PREVOST

Instruction Sheet

IS-91079

REPLACEMENT TACHOMETER

FIGURE 1: TACHOMETER INSTALLATION AND SETTING

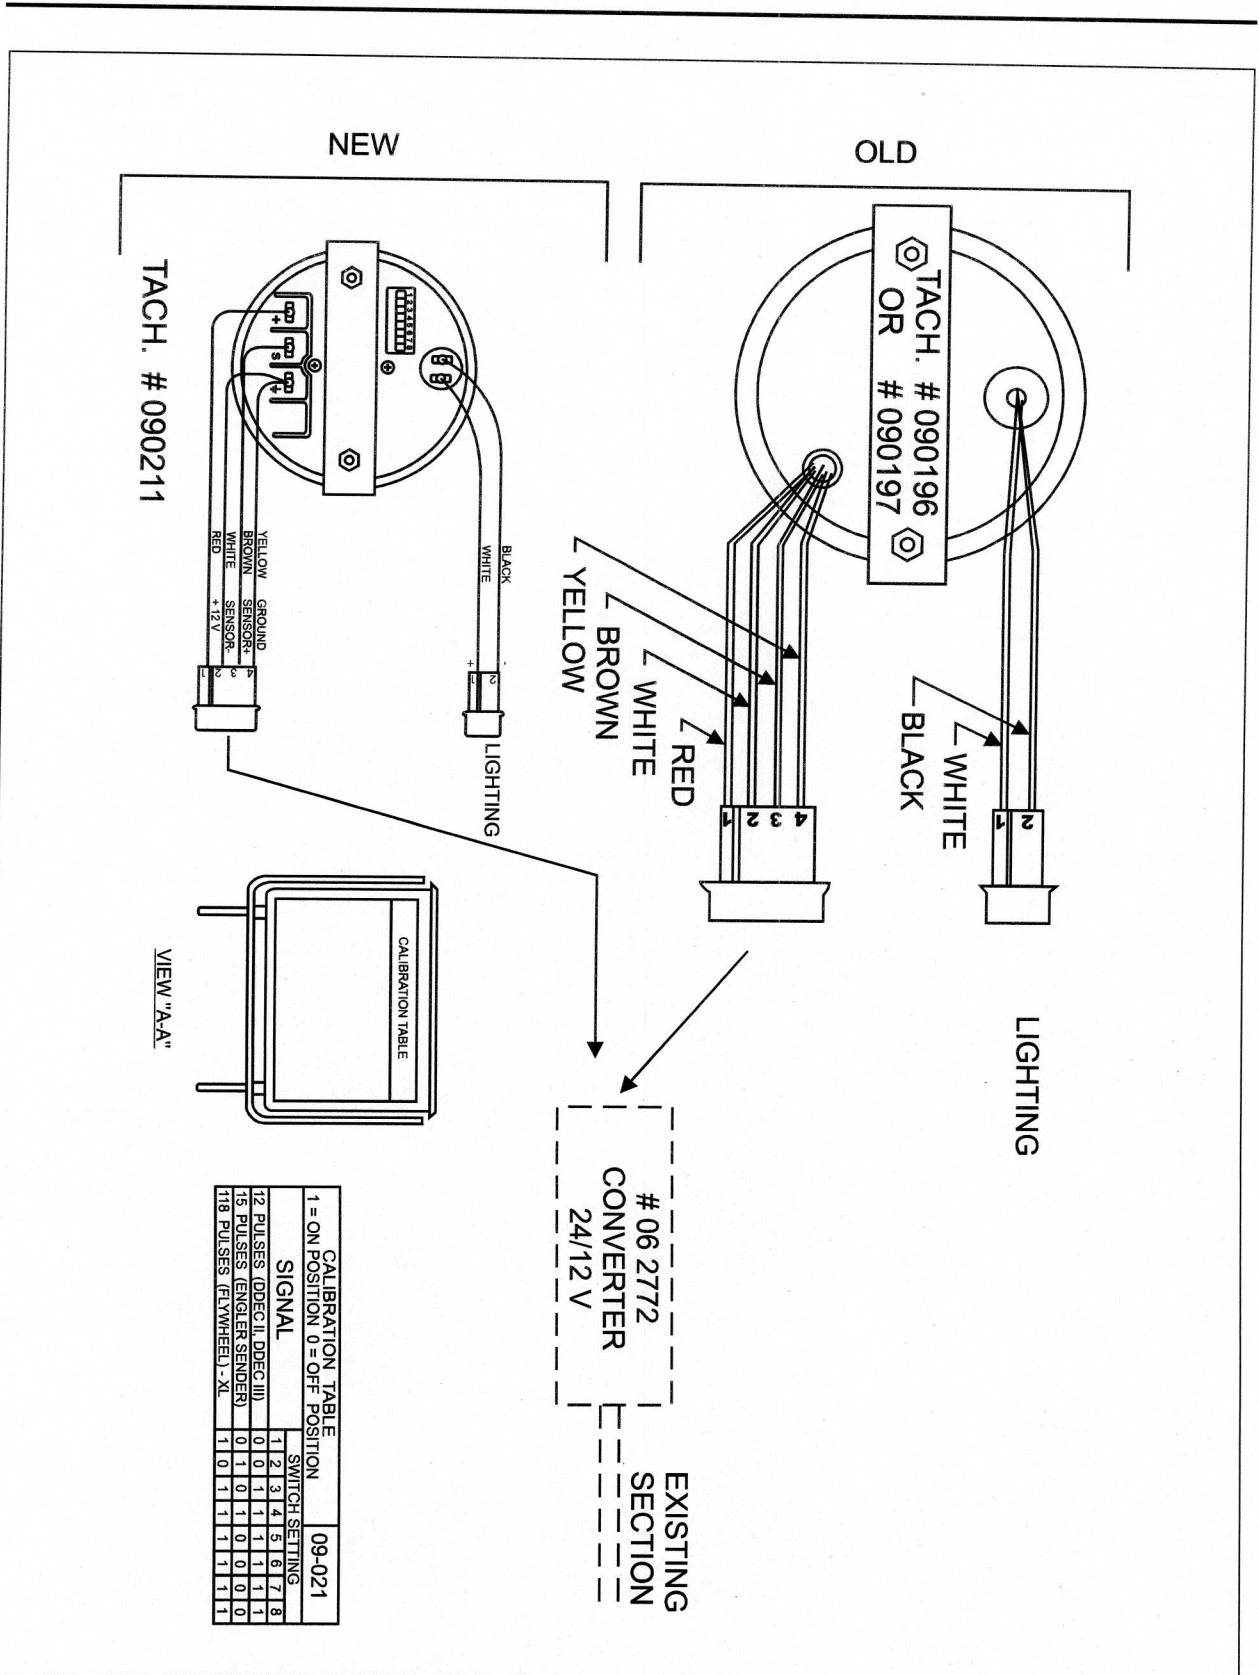
Note: When replacing #090196 or #090197 tachometer, only tachometer #090211 is needed. When replacing #090210 or #090207 tachometer kit, kit #090212 is necessary (see description below).

1. Disconnect and remove old tachometer.
2. Set DIP switches on new tachometer (see chart in figure 1).
3. Install and connect new tachometer and regulator as per figure 1.
